Panel Report

**Moreland Planning Scheme Amendment C164
Brunswick Activity Centre former industrial land**

7 August 2018

Figure 3 Impact of quarry on 10 Pitt Street

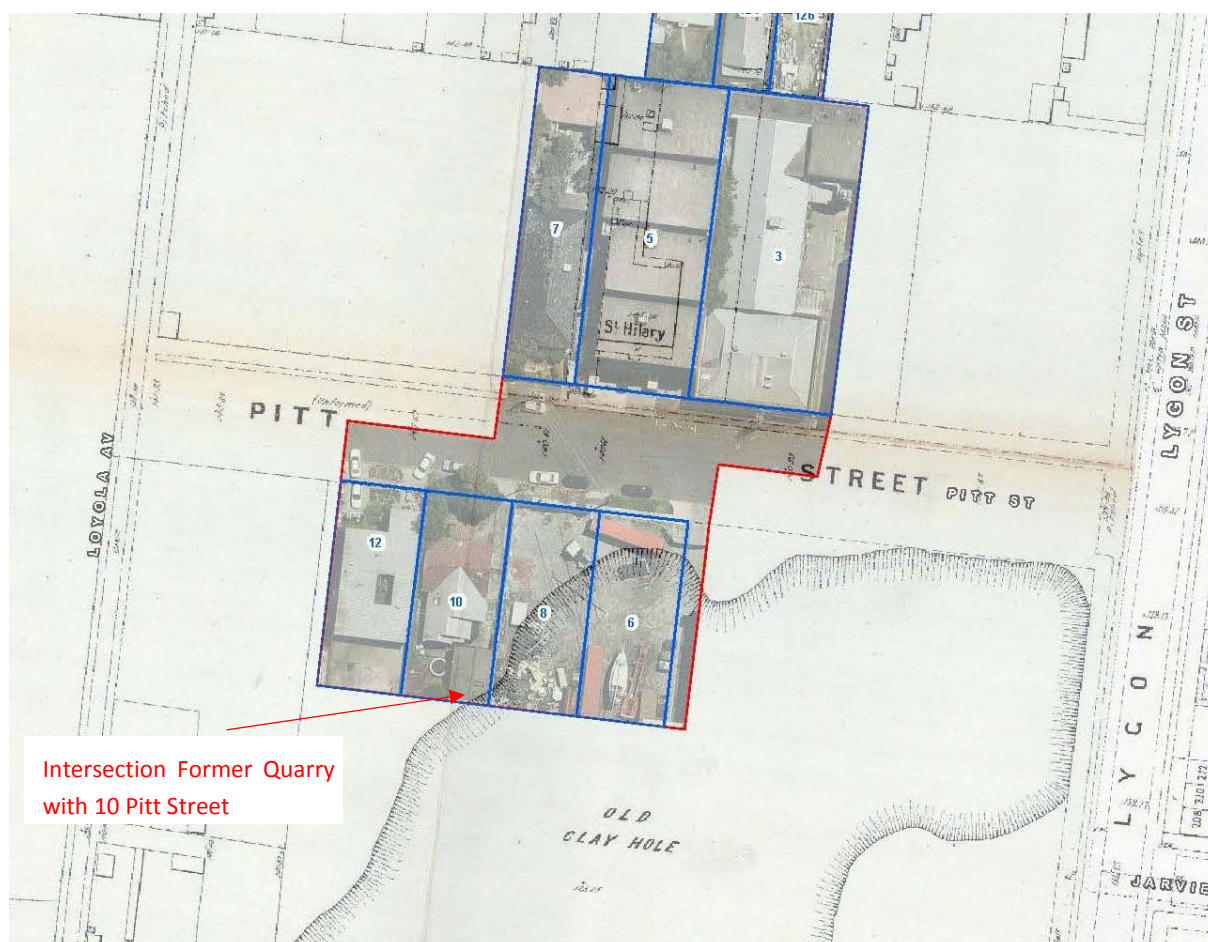
For Pitt Street, the contamination source is not groundwater but the historic quarrying of the land and uncertainty of the type of fill that was used to fill it. The quarry crosses the south east corner of 10 Pitt Street (Figure 3), however Mr Kluckow accepted there was some uncertainty with the mapping and whether immediately adjacent land was impacted.

The evidence that has been put by Council is that a very small portion (around 5 per cent) of the land at 10 Pitt Street was historically used as a quarry and filled with unknown material, and the full application of the EAO to the land was appropriate. The Panel notes the mapping of potential contamination in the planning scheme is not the same as other environmental risks such as flooding where it is only the risk that is mapped. Irrespective of the extent of potential contamination, all of the land has the EAO applied as there is still uncertainty on the extent of it and whether it exists at all.

The evidence that Council has presented relies on historic maps that show the outline of a quarry overlaid by current street layout and lot boundaries. While the contamination source (quarry and its subsequent fill) only affects a very small part of the land, any modifications to the dwelling that is located outside of the quarry area would trigger the need for an environmental audit, even a first storey extension that does not create ground disturbance, as the EAO is to be applied to all of the land.

Unlike its consideration of the land in Ann Street, the Panel agrees that MD1 does apply as the land has a history of mining (quarrying) and therefore Council must satisfy itself that the land is in a suitable condition for the sensitive use.

Figure 7 17-19 Hope Street

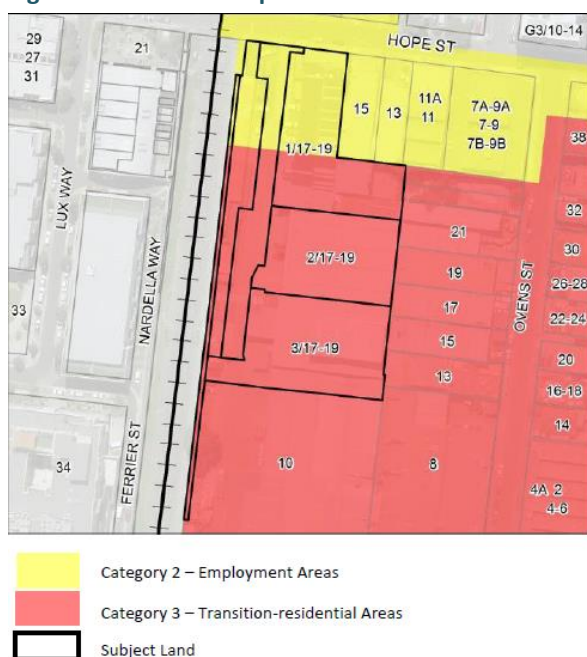
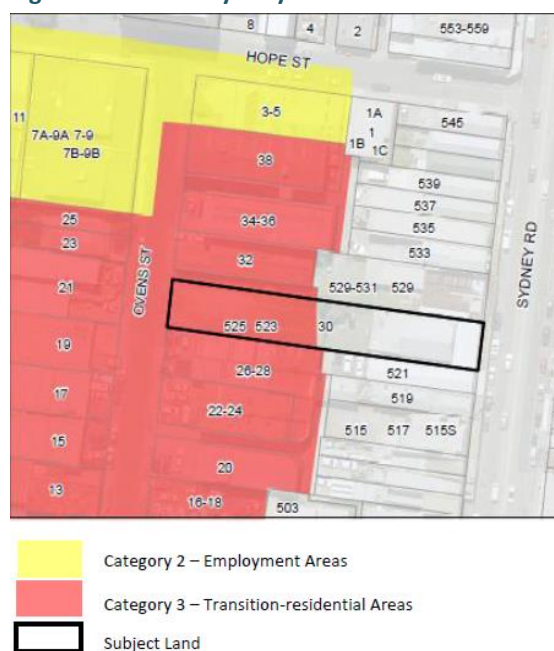
17-19 Hope Street (Figure 7) and 523 Sydney Road (Figure 8) are already in the C1Z and are not proposed to be rezoned although the rear of both sites sit within a Category 3 area (MILS Area 72).

3. **Delete the Environmental Audit Overlay from 6 and 8 Ann Street, Brunswick.**
4. **Delete the Commercial 1 Zone from the rear (western) portion of 523 Sydney Road as defined by Category 3 land and replace it with the Mixed Use Zone.**

Figure 16 MILS Areas 41, 42, 43 and 73 – proposed built form guidance

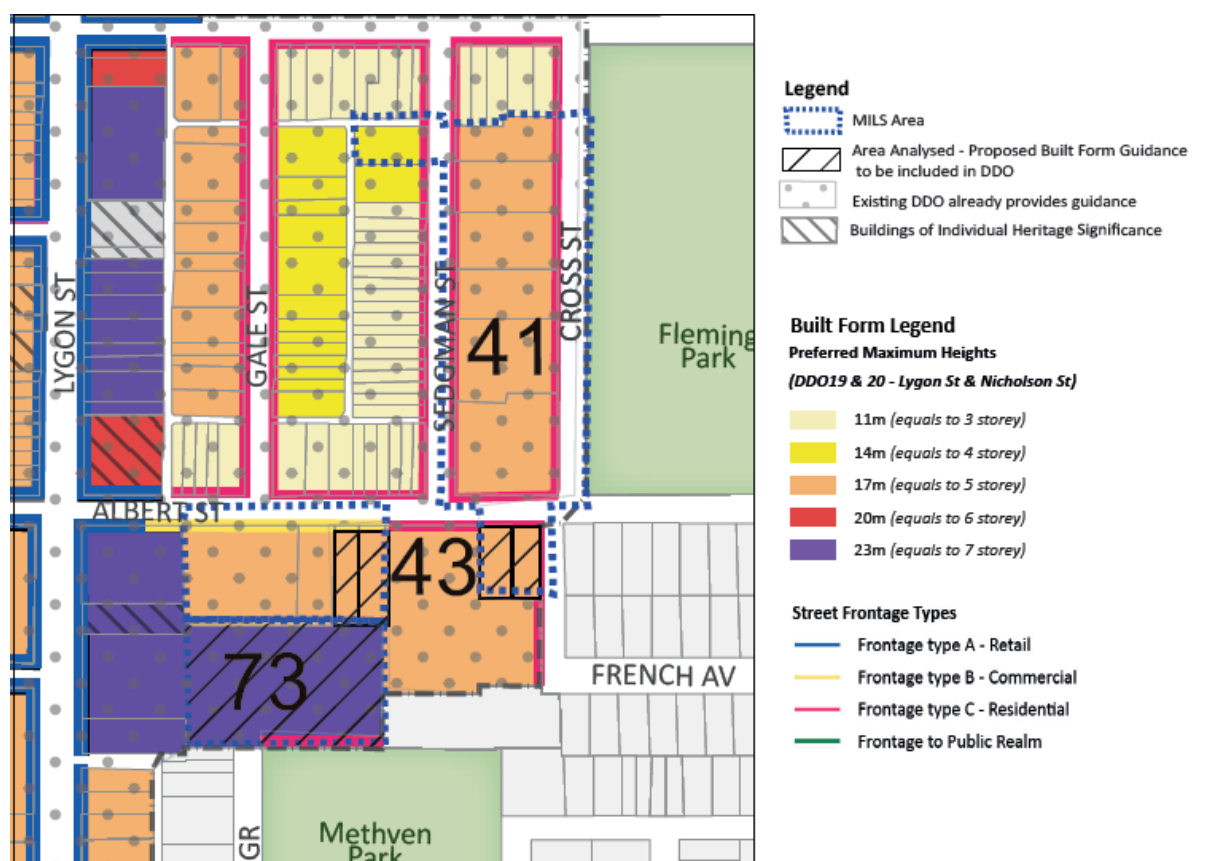
A fine grained residential area is located to the north of Albert Street, that is centred around Gale Street, Sedgman Street and Cross Street. The current building height for this area varies between 11 metres (east and west of Sedgman Street), 14 metres (east of Gale Street) and 17 metres (west of Gale Street). The Amendment proposes to increase the building height between Sedgman Street and Cross Street from 11 metres to 17 metres.

9. **Amend Schedule 19 to the Design and Development Overlay to delete the 17 metre height limit for MILS Area 41 north of Albert Street and replace it with 14 metres.**

Figure 18 160-164 Victoria Street

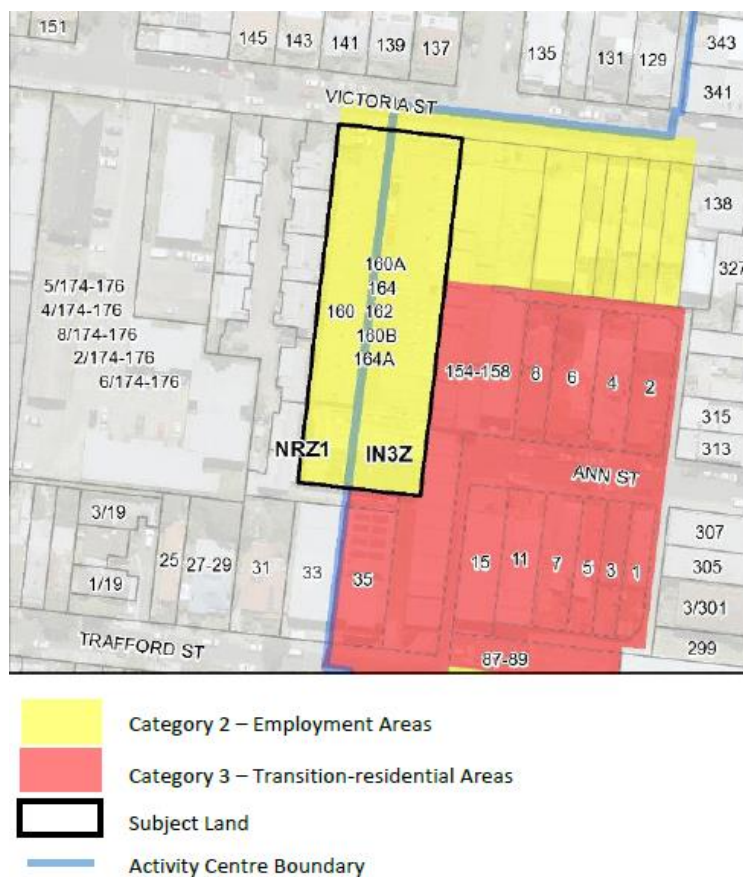
160 Victoria Street (Figure 18) is within MILS Area 44 (Category 2) and currently has split zoning with IN3Z on the eastern side of the property and NRZ1 on the western side. The Amendment seeks to place the whole of the land within the C1Z. This is consistent with the MILS implementation strategy and is supported.

Figure 19 154-158 Victoria Street

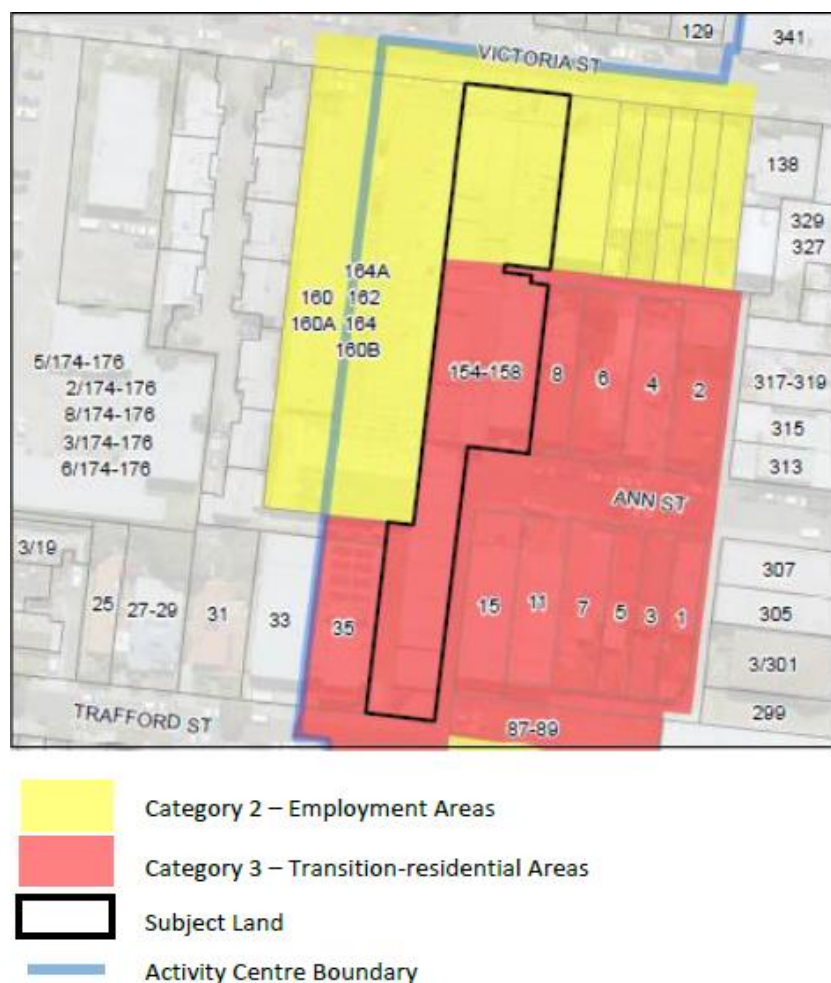
154-158 Victoria Street comprises 8 land parcels (Figure 19). The northern part of the land fronting Victoria Street sits within MILS Area 44 (Category 2), whilst the southern part of the land with a frontage to Ann and Trafford Streets are within MILS Area 45 (Category 3).

The C1Z is to be applied to all of the land, however the Background Report supports the residential use at ground level for land in Ann and Trafford Streets⁹. DDO19 proposes a preferred height of 14 metres. Council submitted that a residential use at ground level to the rear of the land would be a requirement of any proposal for the land.

10. **Delete the Commercial 1 Zone from the rear of 154-158 Victoria Street, Brunswick as defined by Category 3 land and replace it with the Mixed Use Zone.**

Figure 23 MILS Areas 38 and 39 – proposed built form guidance

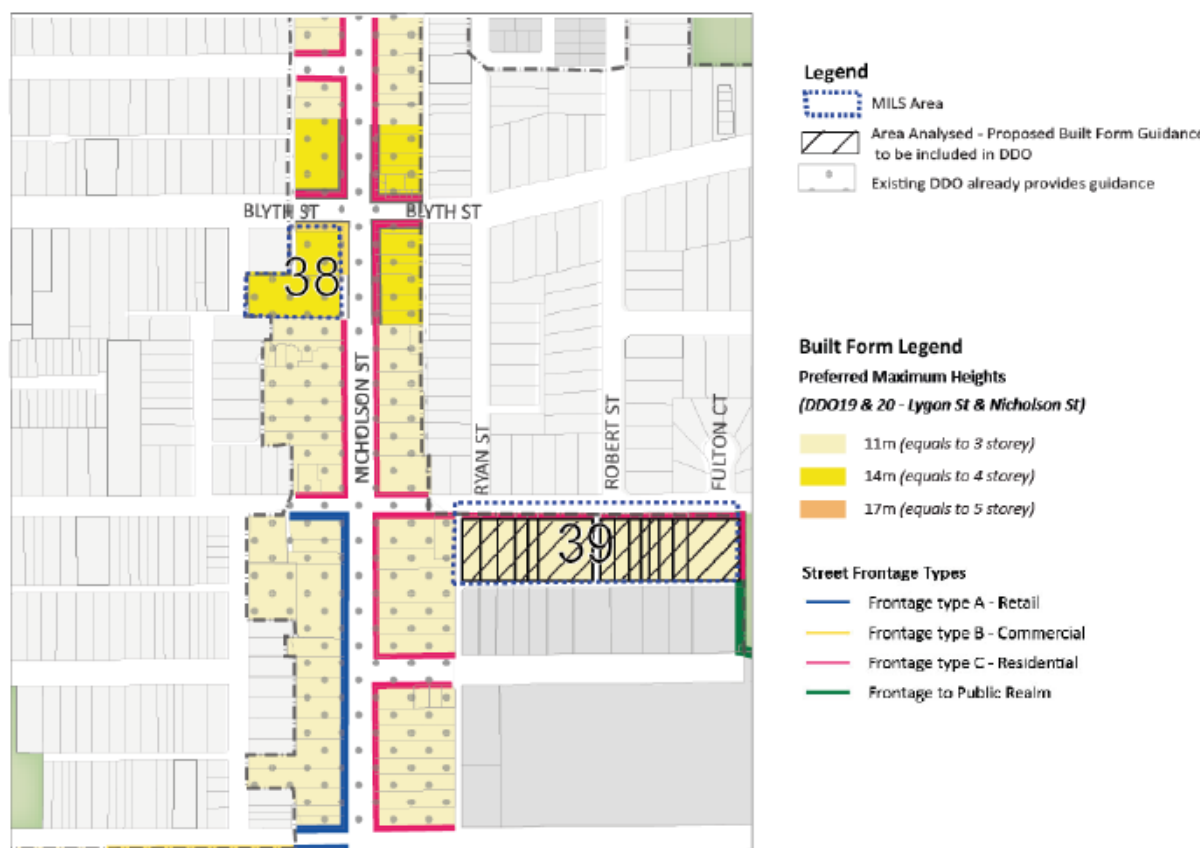
Submitter 11 of 30 Victoria Street submitted that this property should have a 15 metre height limit.

Council submitted that the proposed preferred maximum 11 metre height limit was appropriate given the primarily single storey properties adjacent to this precinct and the matching 11 metre height control on Nicholson Street at the western end of Victoria Street.

Map 1A: Lygon Street Local Area Built Form Controls (North)

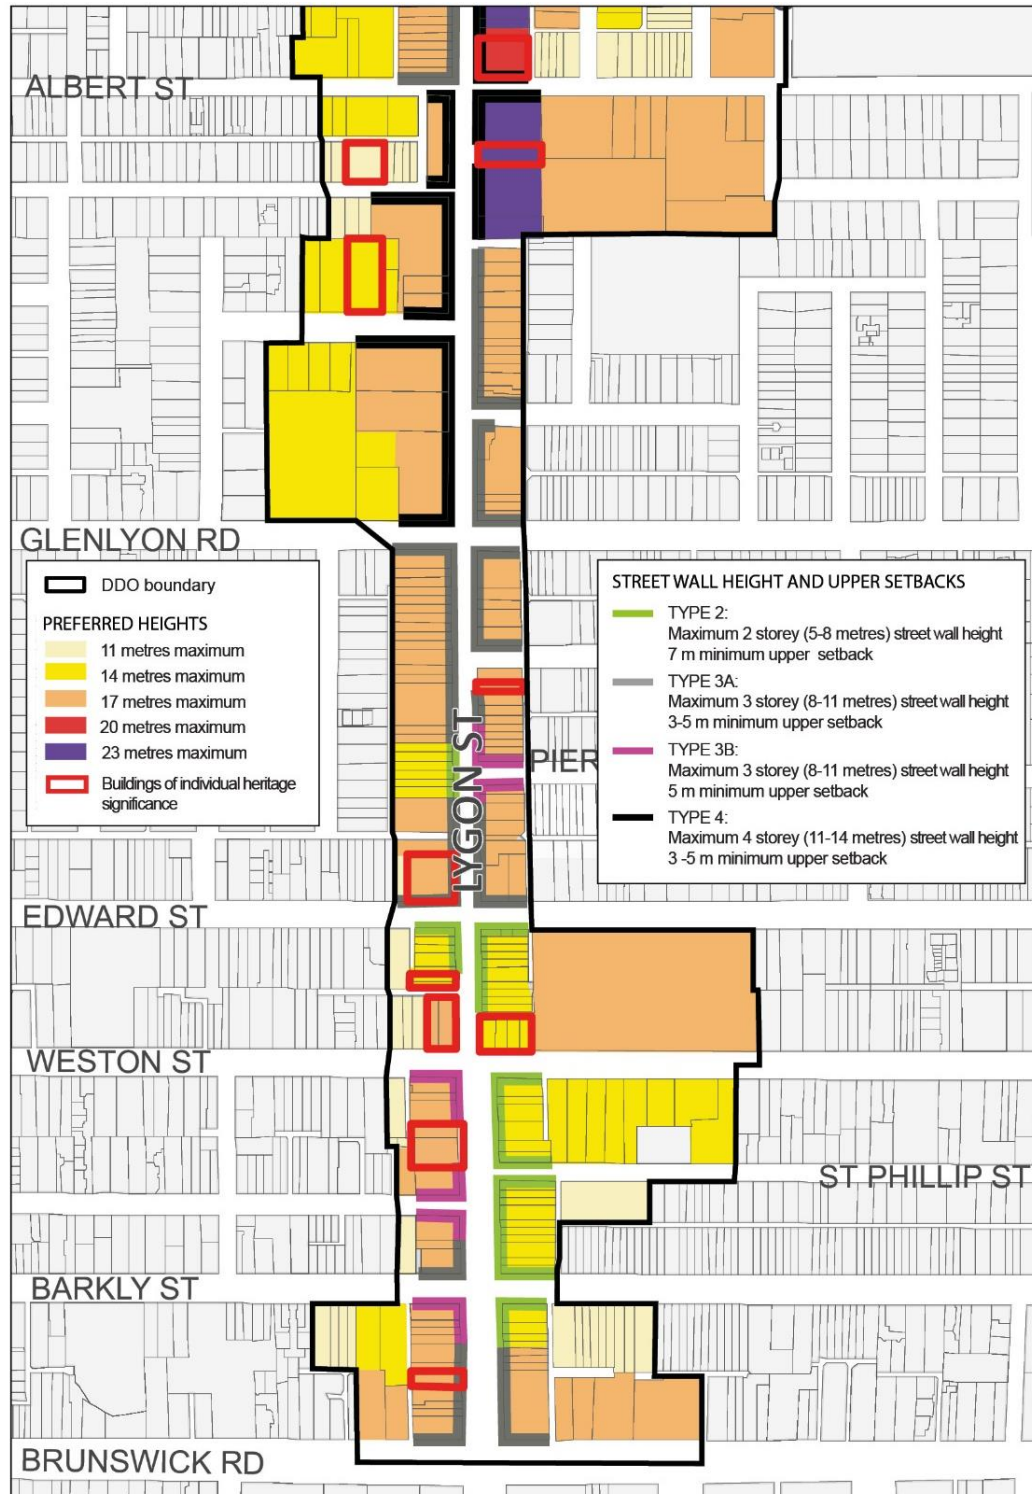
NOTE: COUNCIL TO CHANGE CROSS STREET HEIGHT TO 14 METRES.
